## **ADDENDUM NUMBER THREE**

### **YAVAPAI HILLS #1 LIFT STATION REHABILITATION PROJECT**

**DATE OF ADDENDUM: May 13, 2024**

CIP NO. 2105-004  
VOLUME 1 OF 4  
FOR CONSTRUCTION  
ADDENDUM 3

DRAWING NO.  
C-101

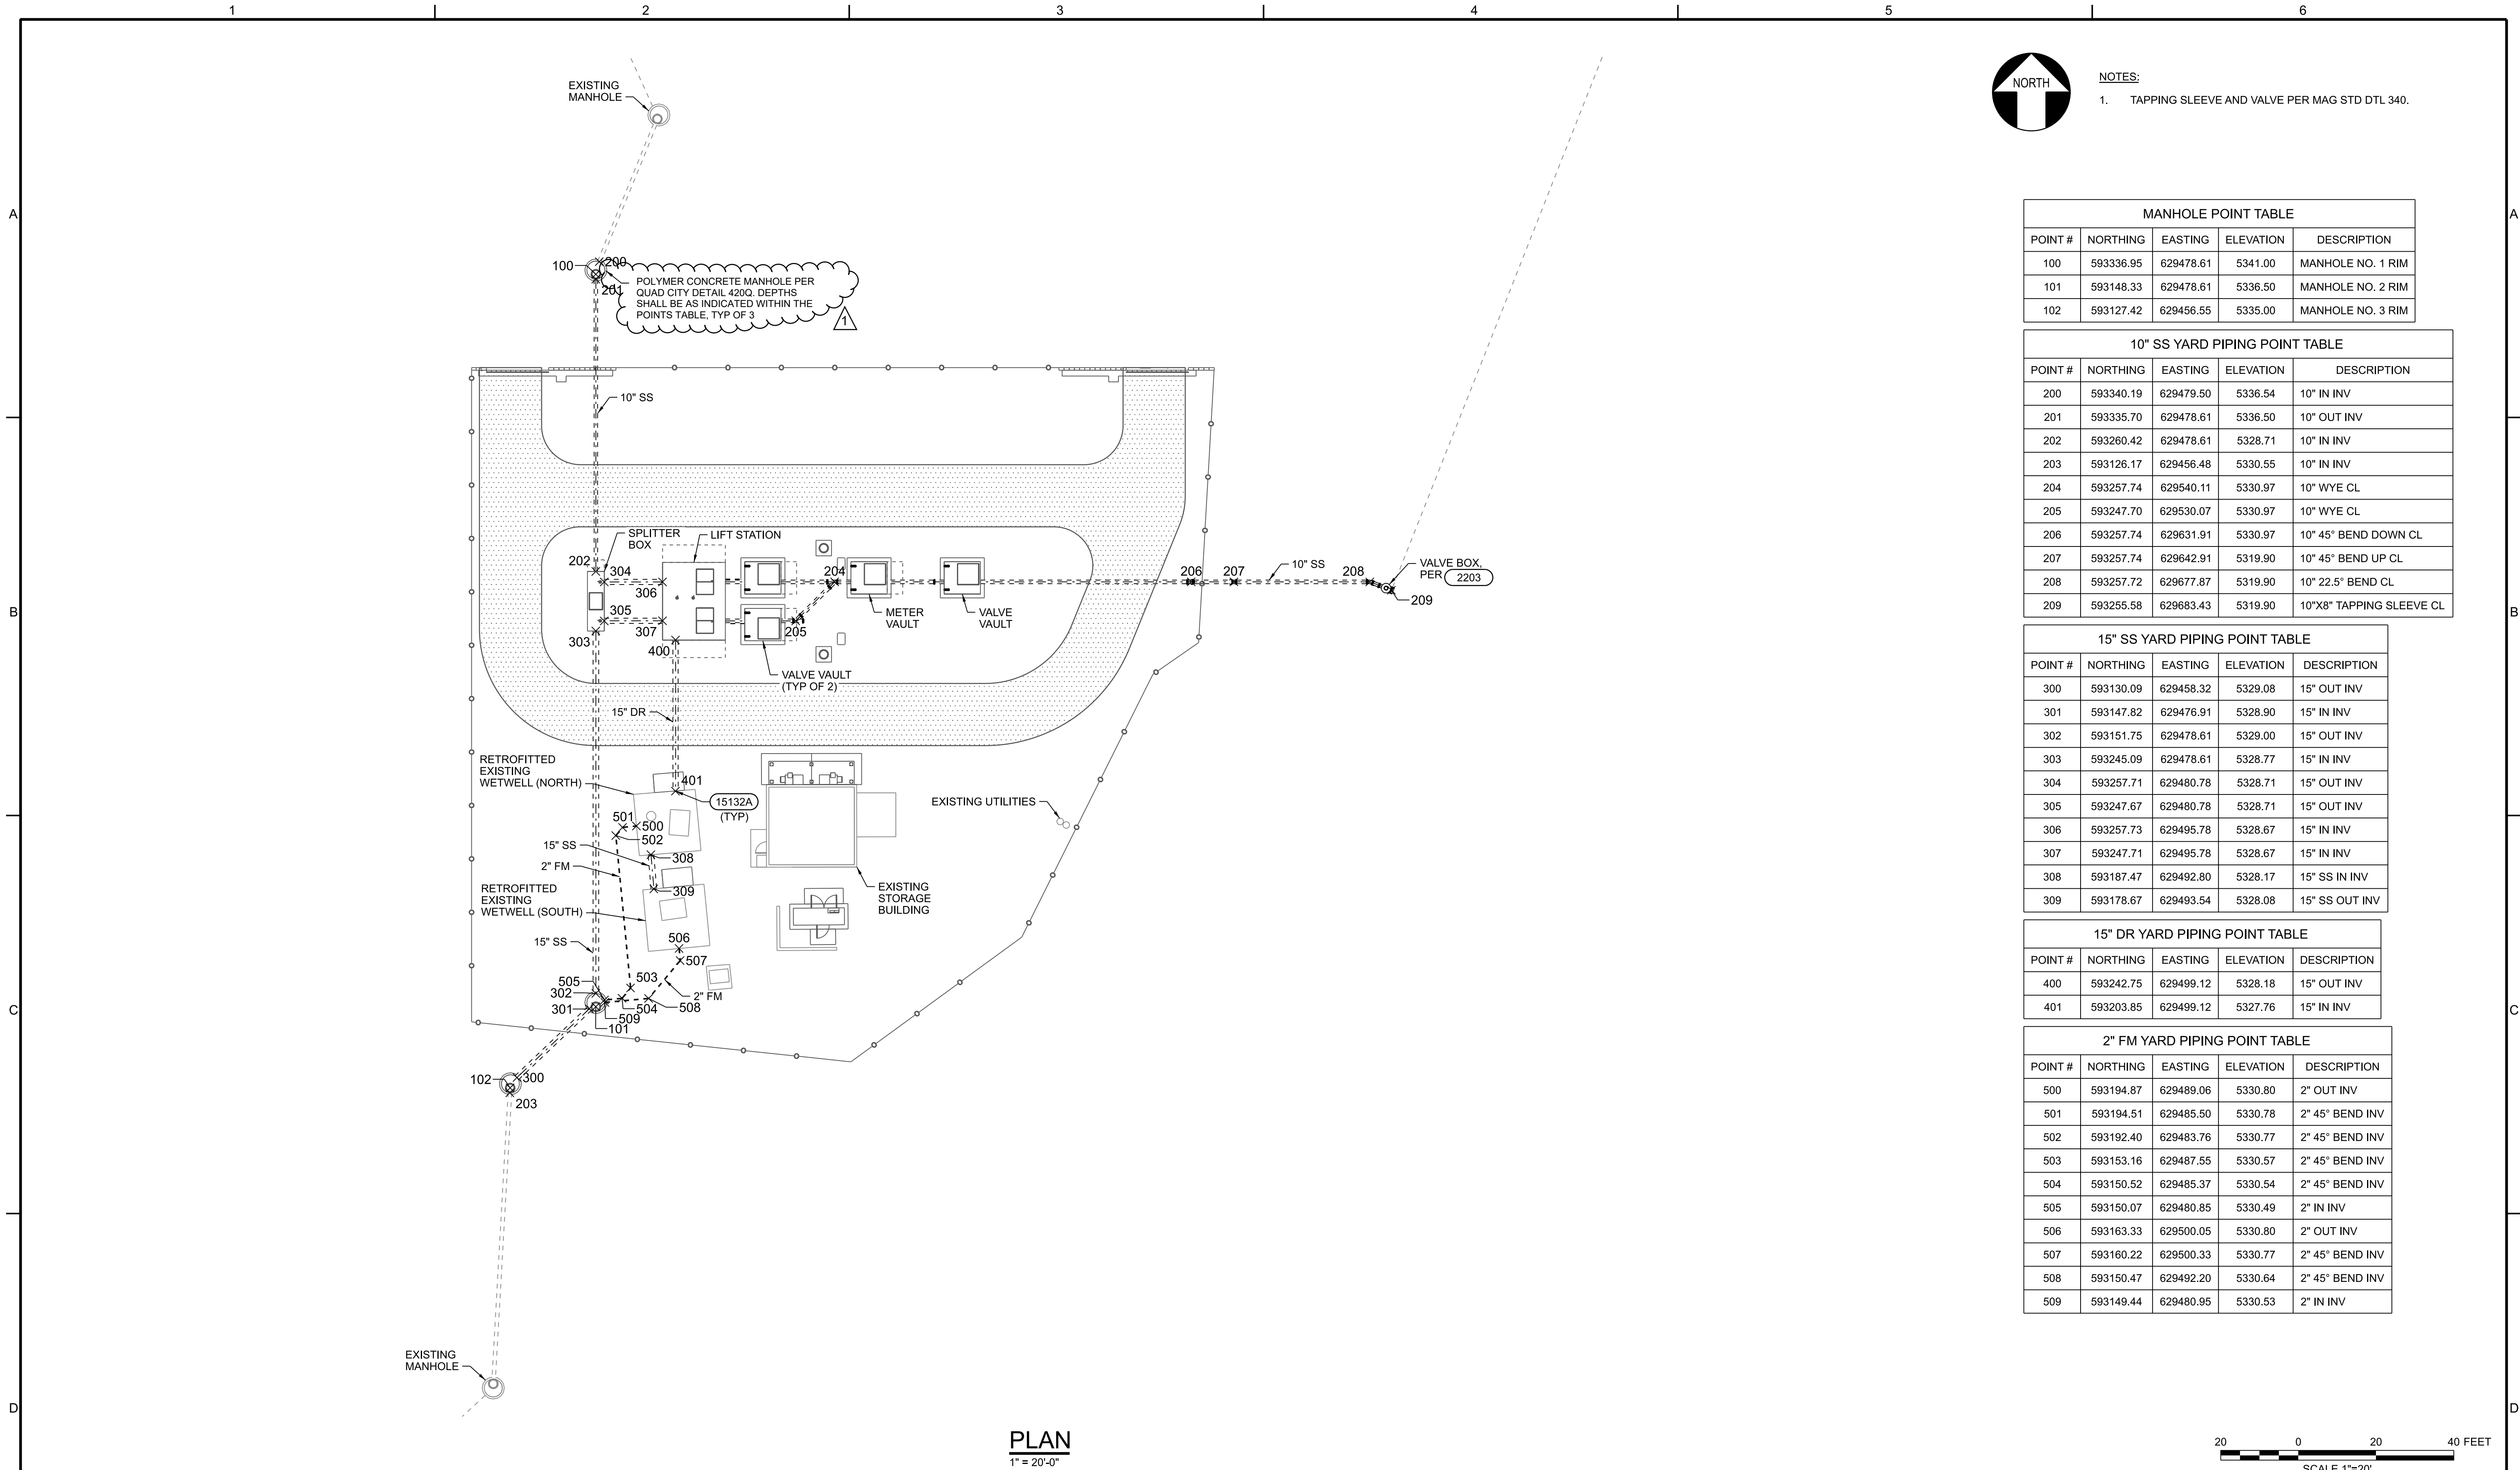
**Question:** On page C- 101 there are gravel designations called out throughout the site. Please provide a detail of what exactly is being asked for by "Gavel".

**Question:** The shade canopy shown on C- 101 and E- 102 looks about 26' X 8' in size? Can you provide some details on the height and slope of roof?

**Response:** Refer to detail 2504 provided within the standard details book.

**Response:** Slope shall be 0.03 ft/ft. Height shall be coordinated with the final procurement of electrical equipment to be housed under the canopy. At a minimum provide 2' clearance between the top of the equipment and the shade canopy.

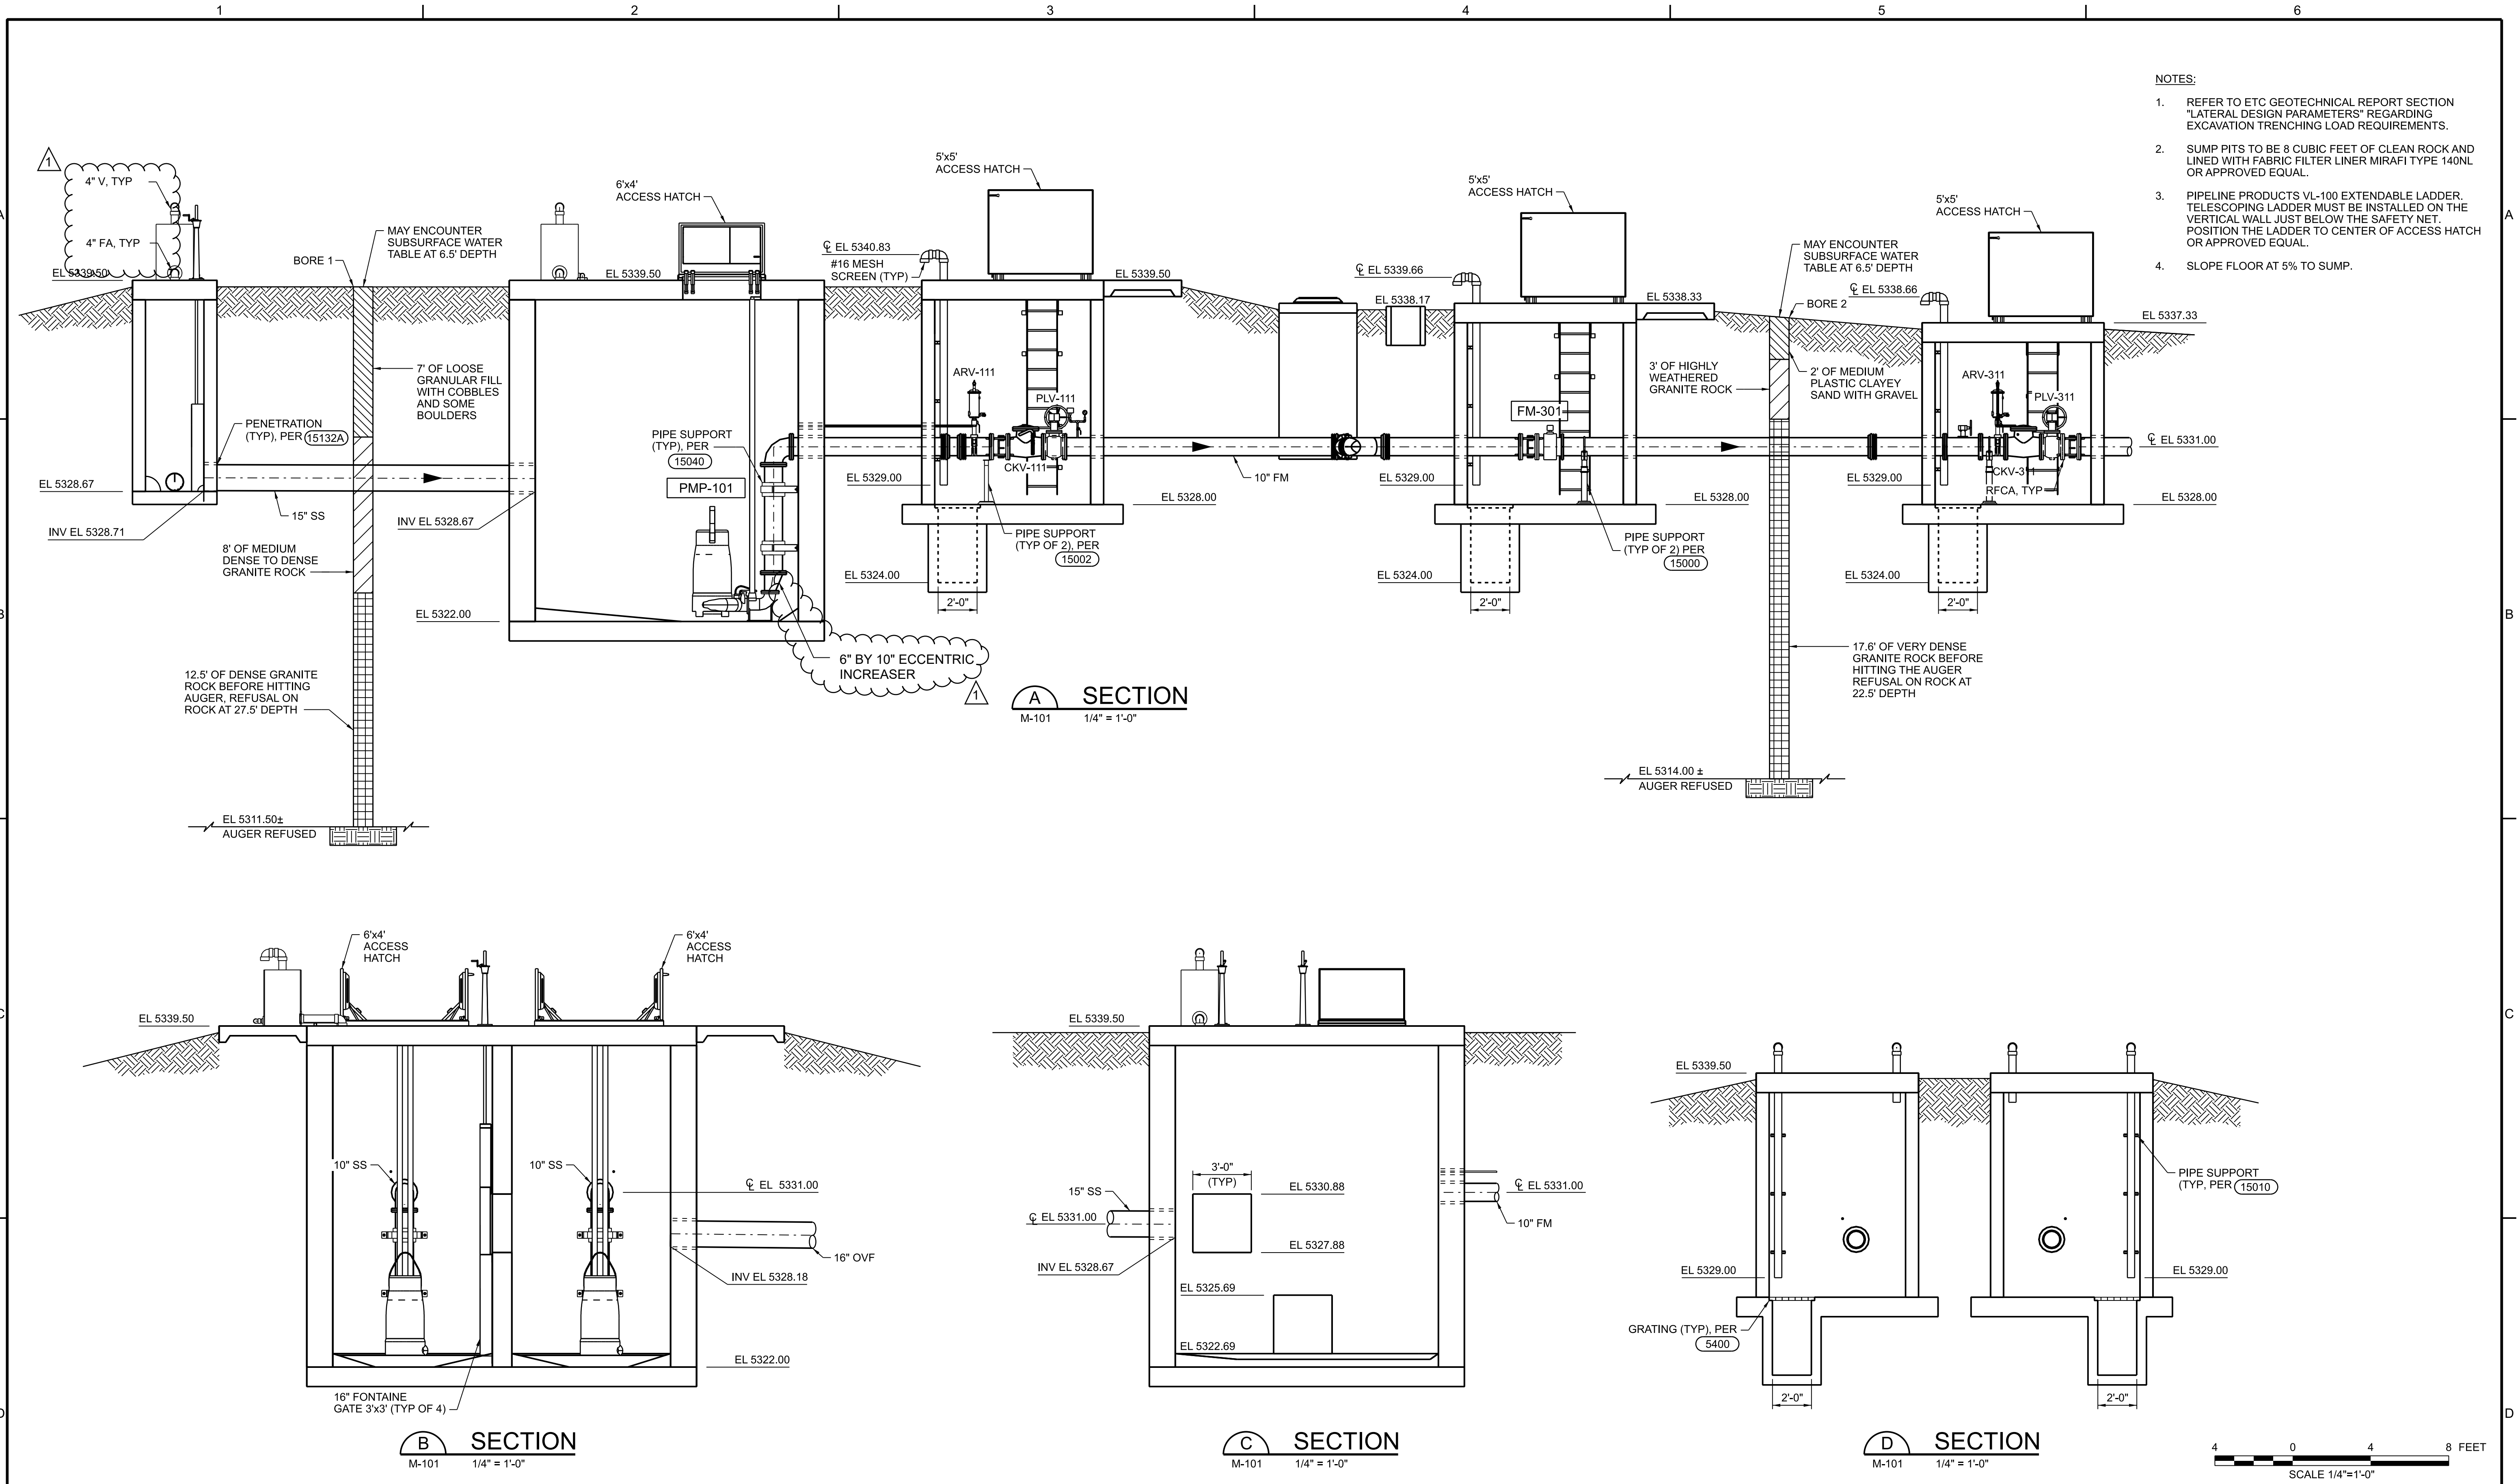
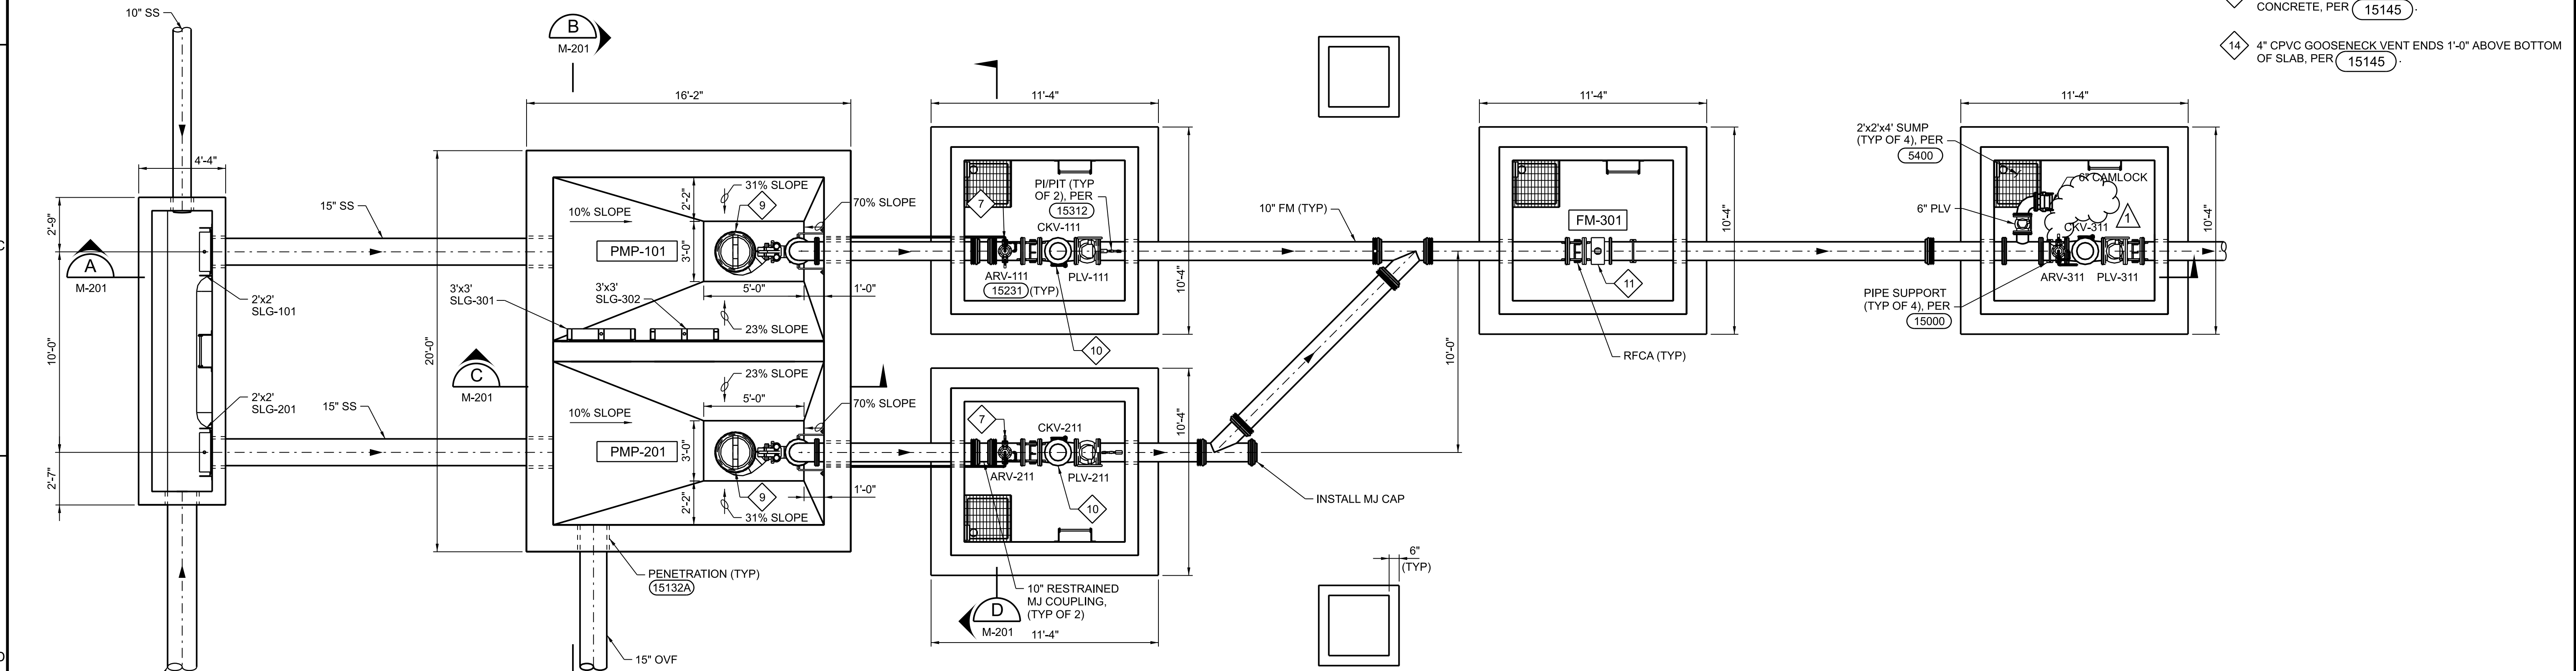
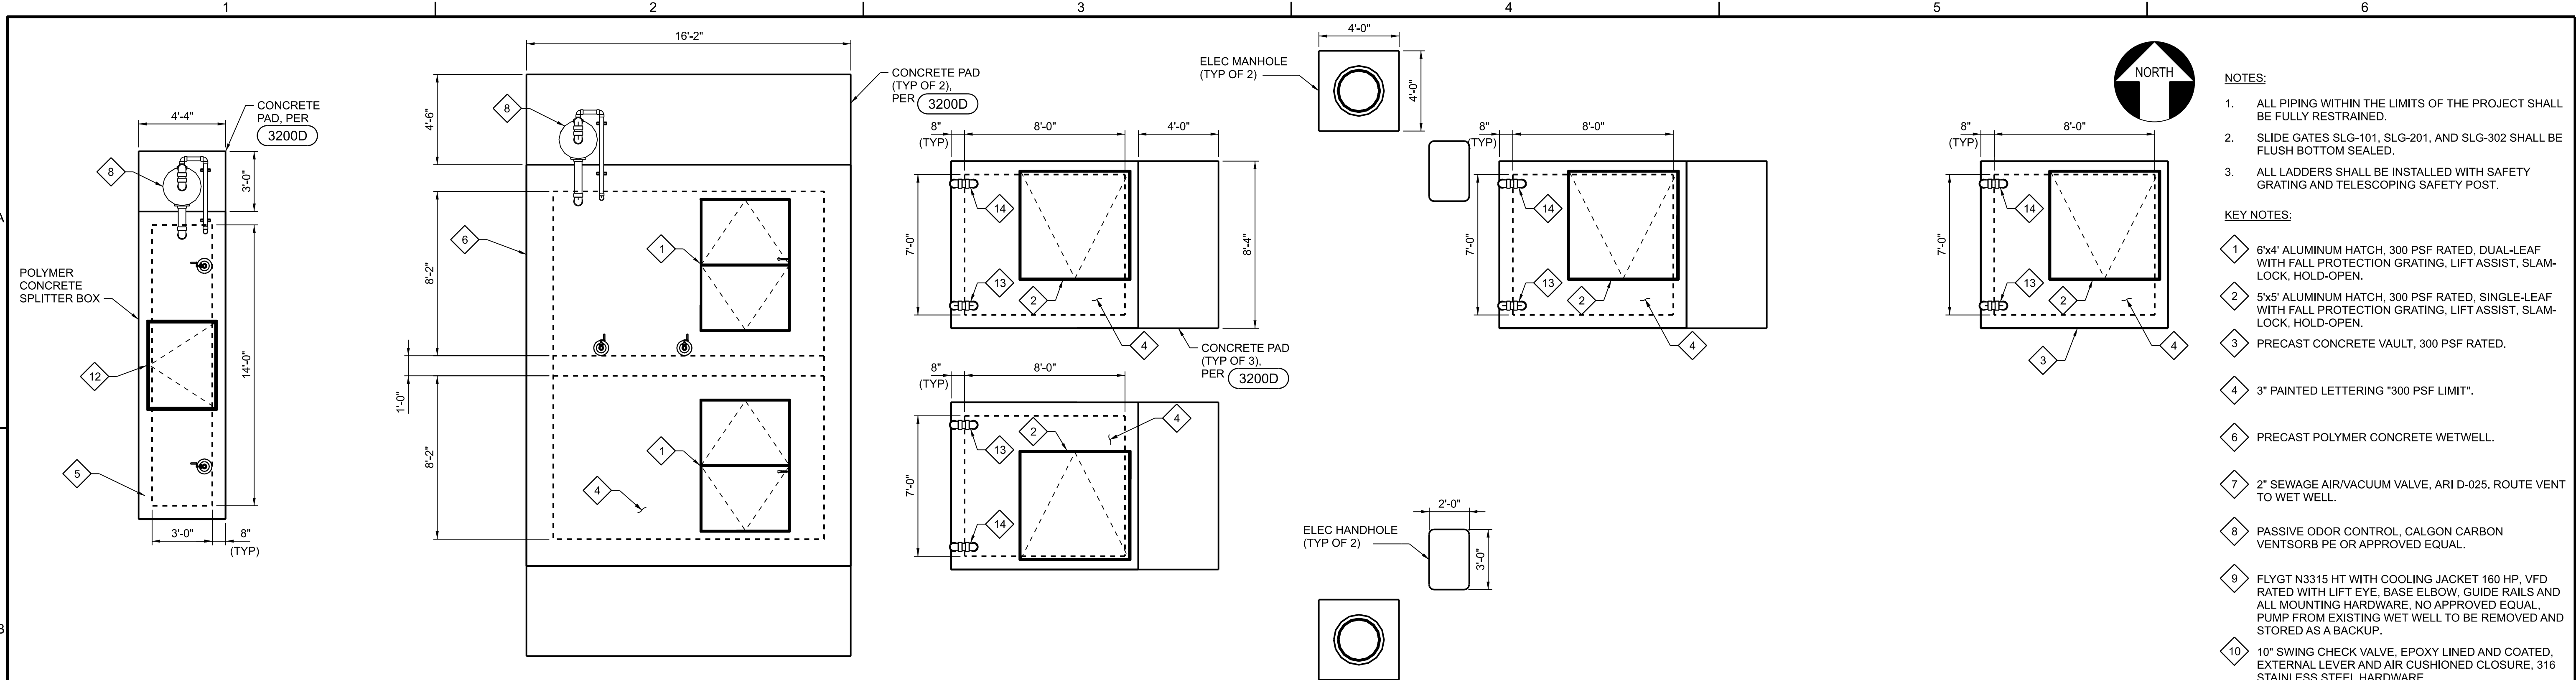
**Question:** The Addendum 2 set of plans have only one reference to FRP. Sheet G-002. Vent is referenced on sheet M-101 as 4"CPVC Note 13 and 14. Where are the 200 LF on the latest set of plans?

**Response:** Both the FA and V piping shall abide by keynotes 13 and 14 on M-101, provide these as CPVC. The 200 LF noted within the bid schedule shall be removed. All FA and V piping shall be CPVC. The cost of the FA and V piping shall be included in the cost of the structure.
